Field campaign

Topic	12MY,13MY and 14MY Power Boot Campaign RoW (SC16/24)
Market area	Hongkong-Macau (5HK),Russische Föderation (5RU),Australia E04 Bentley rest Asia and Australia (6E04),China 796 VW Import Comp. Ltd (Vico), Beijing (6796),Germany E02 Bentley rest Europe (6E02),Japan E03 Bentley Japan (6E03),Russian Federation 935 Volkswagen Group RUS (6935),United Arab Emirates E06 Bentley Middle East and Africa (6E06),United States E05 Bentley USA and rest America (6E05)
Brand	Bentley
Transaction No.	2045092/3
Campaign number	EA62
Note	
Type	Service Campaign
US code

New Continental

Figure 1a

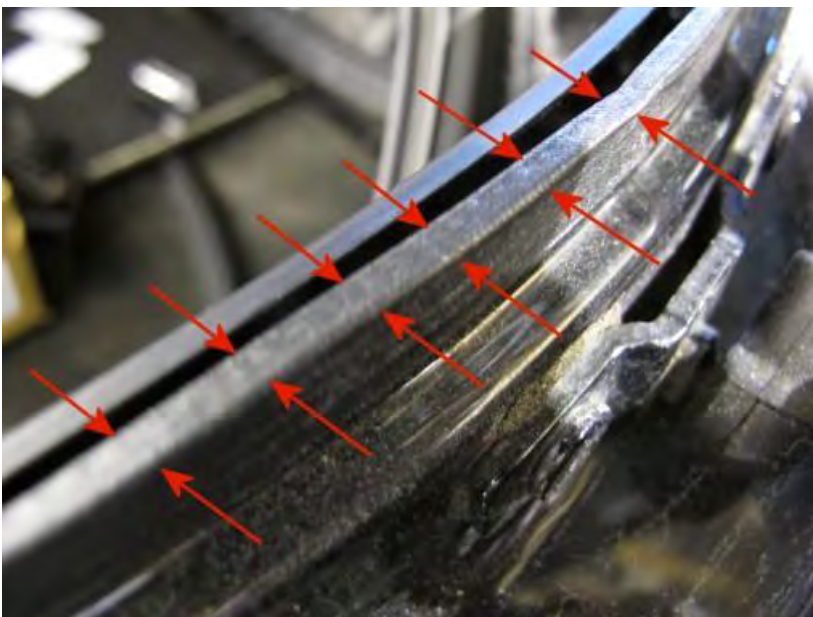
1. Ensure the boot lid seal is correctly fitted (see Figure 1a) specifically the knock-on strip element of the seal must be fully engaged on the lip of the boot aperture and not as shown in figure 1 where it is displaced by the boot trim. Ensure the obscuration tape fitted to the boot aperture flange is not restricting seal fitment (see Figure 1b). Check seal is correctly orientated, the vulcanised joint -1- should be to the centre line (+/- 10mm) of the ball joint -2- on the boot lid gas strut (see Figure 2 and 2a)

Figure 3

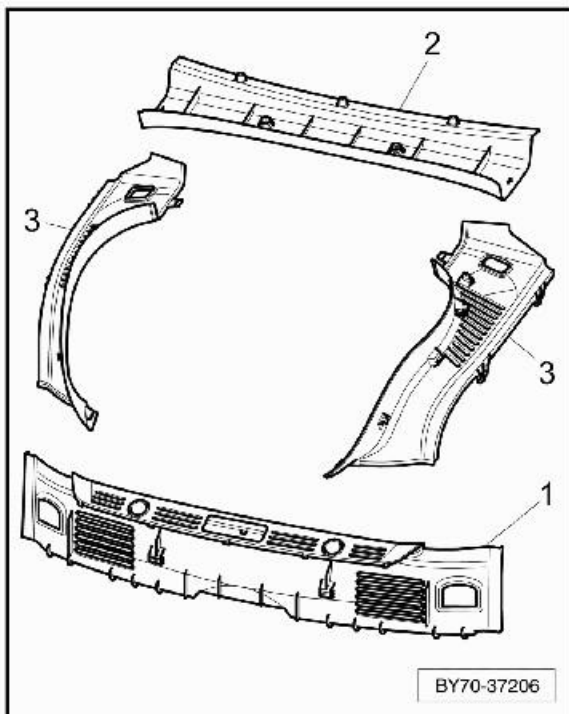
4. Ensure the boot aperture finishers (see Figure 3) are secure, correctly fitted and not compromising the boot lid seal fitment, rectify and replace damaged clips where necessary

Figure 5

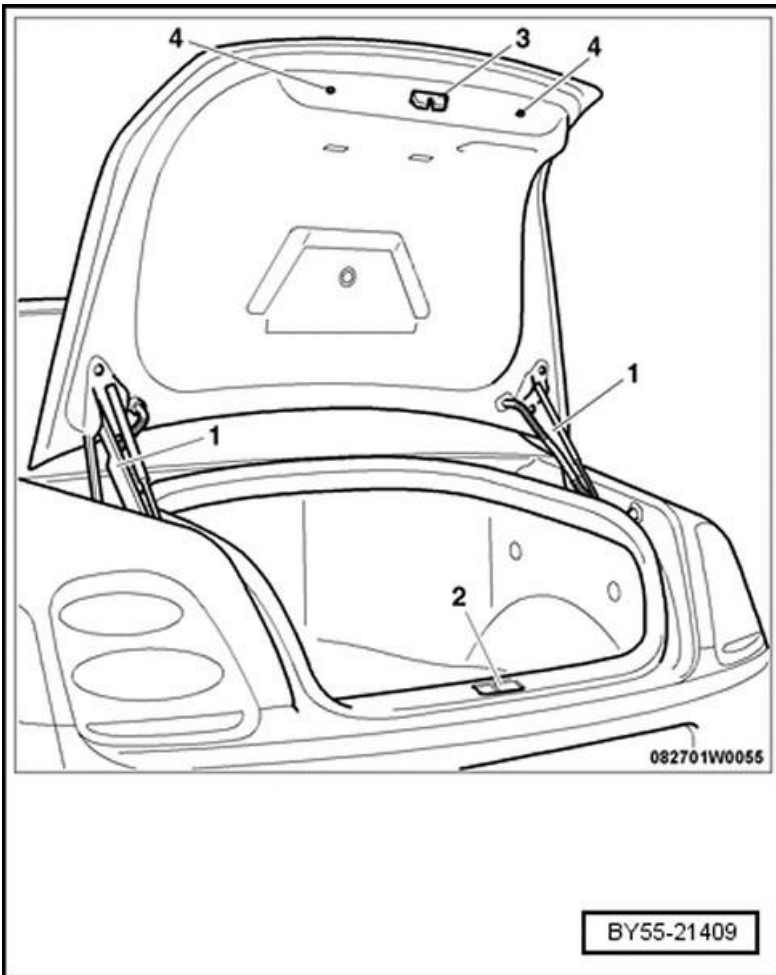
The position of the boot lid can be set by adjusting the hinges (1) or the striker (2). The locking latch (3) is attached directly to the boot lid. It does not have slotted holes and therefore has no means of adjustment. Before any adjustments are made the car must be resting on its wheels and on level ground. Ensure the socket used to release the fasteners is 'as new' and that it is fully engaged with the fastener. Tapping the socket with small dead blow hammer to assist the tool in cutting into the paint to aid engagement is recommended. Releasing the harness conduit clips from the each hinge will assist in access. When applying specific torque to fasteners ensure any adaptors or extensions used on the torque wrench are accounted for in your calculation for applied torque

Figure 6

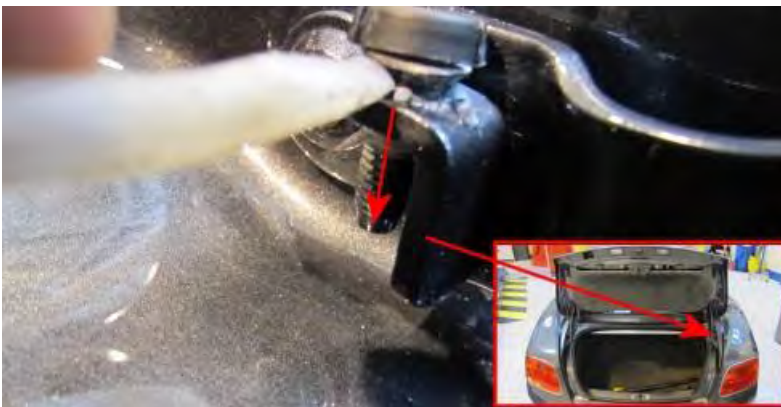
Remove the plastic cap and wind down the boot lid hinge bump stops located on each hinge assembly, these are adjusted back after the setting procedure (see Figure 6)

Figure 9

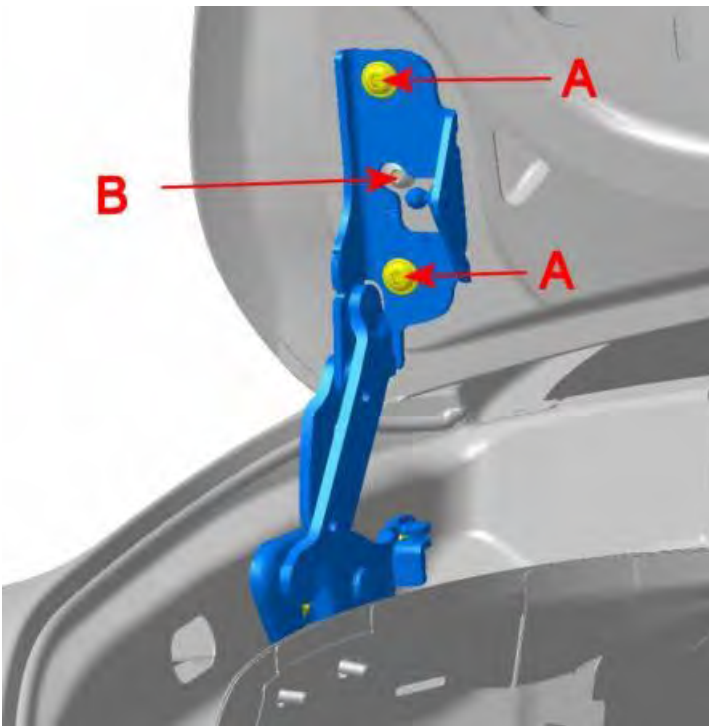
AllCars - Slacken the fasteners (A) securing the boot lid. (see Figure 9) **Note:** do not slacken fastener B at this time. Allow the hinges to "float" ensuring that left and right hinge are not working against each other and operate in same plane without undue resistance. Re-tighten the four fasteners (A) 20Nm \pm 2

Figure 10

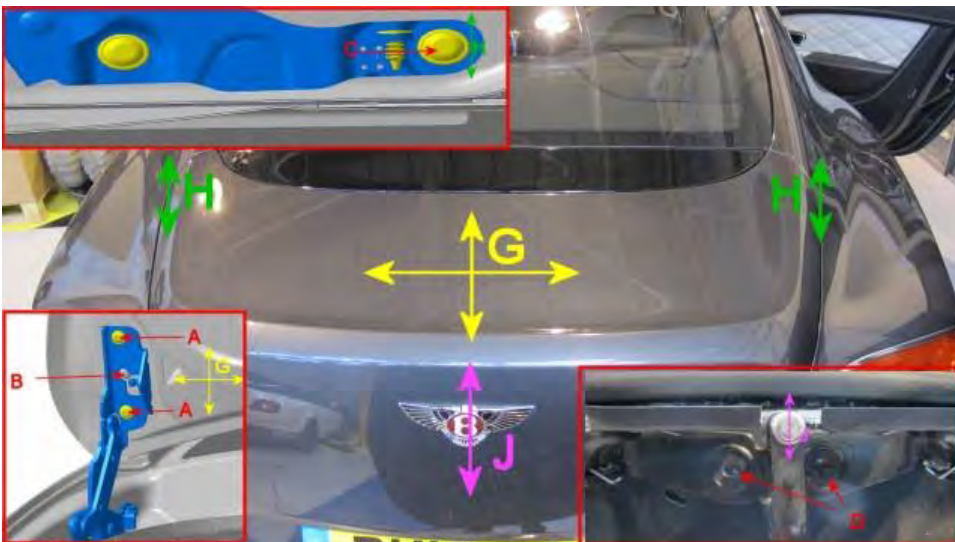
Ensure the boot seal is fitted correctly before manually closing (to control closing avoiding damage in the event that a clash has been introduced by adjustments) the boot lid. Check the boot lid for aesthetic fit and profile.

- Adjustments Reference Figure 10
- (H) Adjustment in height profile adjacent to the rear screen is achieved at the forward, nearest the rear screen, part of the hinge, slacken both hinge fasteners but make adjustments primarily around fastener C to raise or lower at point H. Re gauge check hinge to maintain gauge setting B figure 7 (GT) figure 8 (GTC)
- (J) Adjustment in height profile at the rear of the boot lid is achieved at the striker plate, slacken both fasteners D then raise or lower at point J.
- (G) To achieve panel gaps the boot lid surface can be moved in both axis at the hinge / boot lid connection, slacken fastener B and fasteners A to release the captive plate to allow adjustment

Figure 13

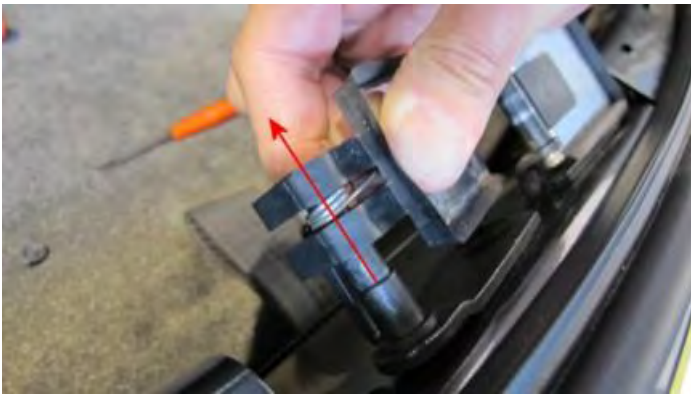
Slide door and spring off the bearing pin discard the original spring (see Figure 13)

Figure 14

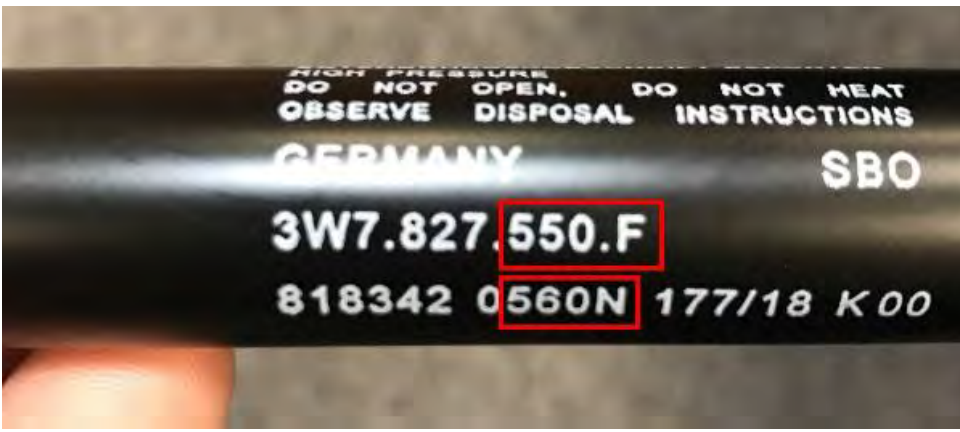
Position the new spring (part number 3W0827441 or 3W0827665) in the removed door. Whilst holding the spring tang back (1) partially fit door and new spring onto bearing pin (see Figure 14)

- Push the door and spring assembly fully (2) onto the bearing pin before releasing the spring tang (1) onto interlock (see Figure 14)
- Fit the new retaining cap (part number 3W0837106)
